PERMIT SET

ALUMNI HALL RENOVATION

EGRESS

LS1

1 LOWER LEVEL EGRESS PLAN

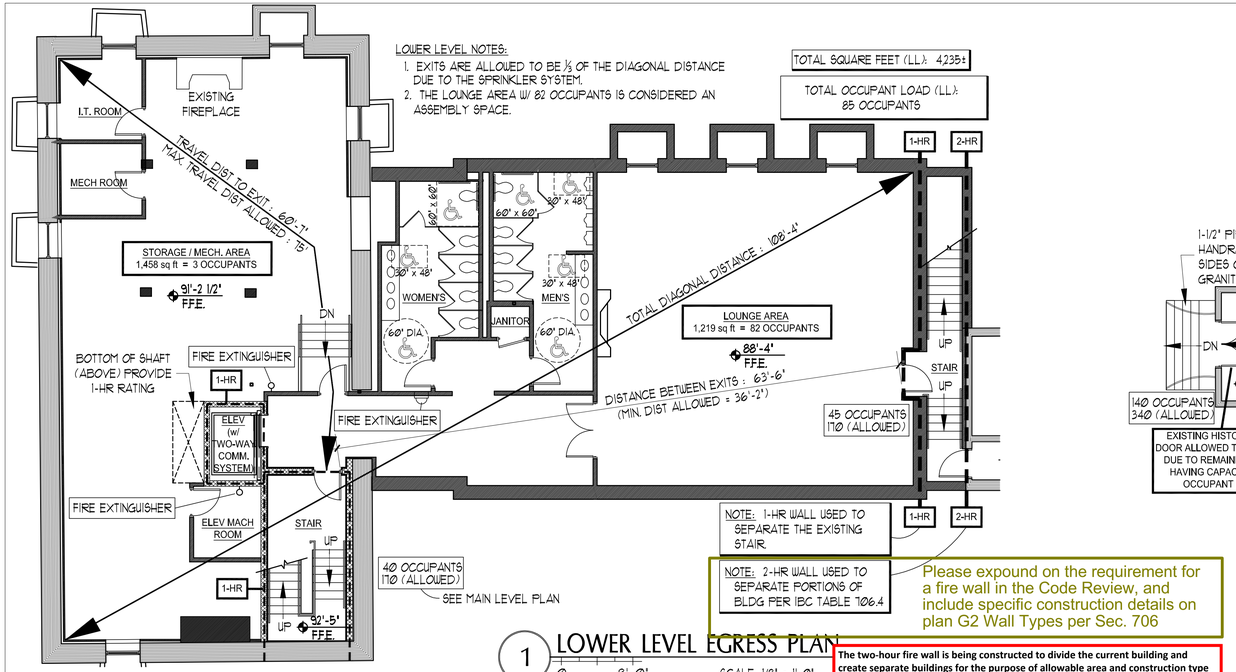
Please expound on the requirement for a fire wall in the Code Review, and include specific construction details on plan G2 Wall Types per Sec. 706

The two-hour fire wall is being constructed to divide the current building and create separate buildings for the purpose of allowable area and construction type requirements. This portion of the building (as shown in these documents) is a mixed use of "Business" and "Assembly" (see the Code Review on sheet LS1). The other portion of the building (also existing) is also a mixed-use of "Business" and "Assembly" and "Storage". Per Table 706.4, for the Use Groups of the current buildings and the Type V construction type, a 2-hour fire wall is required (per footnote a.). This allows the renovations of the portion of the building as shown in these documents to be its own project, without taking into consideration of the remainder of the existing building. See attached details for wall continuity and fire wall terminations as described in Section 706.5 and 706.6.
